SUBJECT: INCORPORATION OF LYCOMING KIT NO. 05K22169 - OIL COOLED VALVE GUIDES FOR TIO-540-AF1A ENGINE IN M20M, MOONEY TLS.
 Revision B - Rework to engine cooling baffle required.
 Revision C - Relocate CHT probe from #5 cylinder to #3 cylinder for -AF1B configuration.

MODELS/S/N AFFECTED: M20M, S/N 27-0001 THRU 27- 0210

FIGURE SI M20-101-2

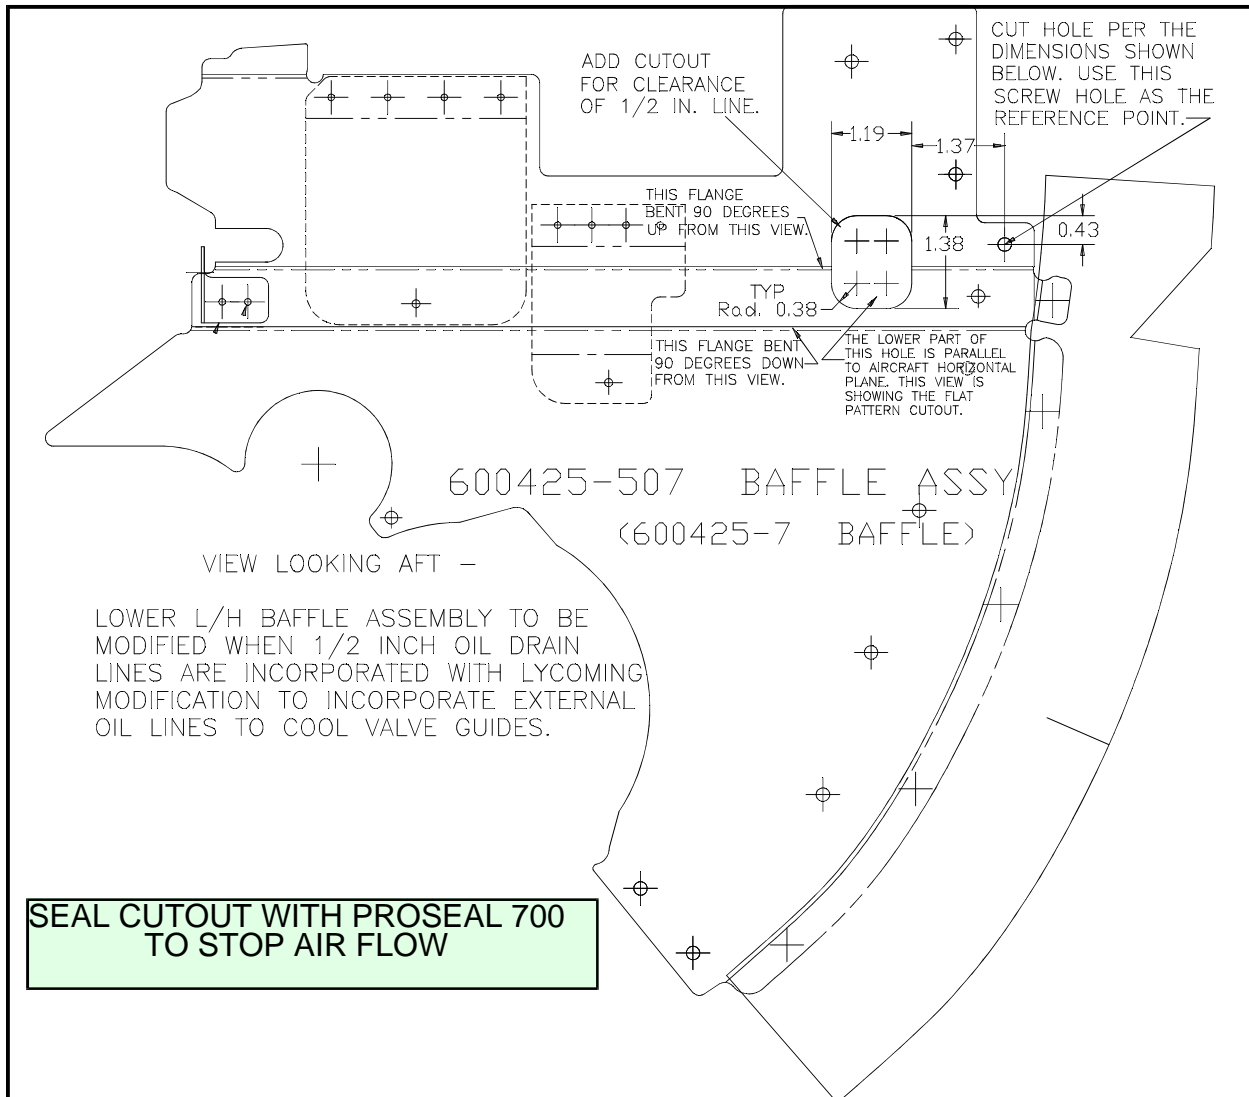
Revision B rework - As aircraft have Lycoming modification kit installed using 1/2 inch rocker box oil drain lines, the engine baffling will need to be reworked per Figure SI M20-101-2.

1. Retrofit in accordance with Lycoming Kit No. 05K22169 & SI No. 1479.
2. Drill .50 dia. hole in RH rear engine baffle. Locate hole from center of RH engine mount clearance hole: 3.6 in. inbd, 0.1 in. up
3. Remove CHT Probe from Cylinder #5. Relocate CHT Probe to Cylinder #3 mounting boss.
4. Reroute and secure all wire harnesses as needed.
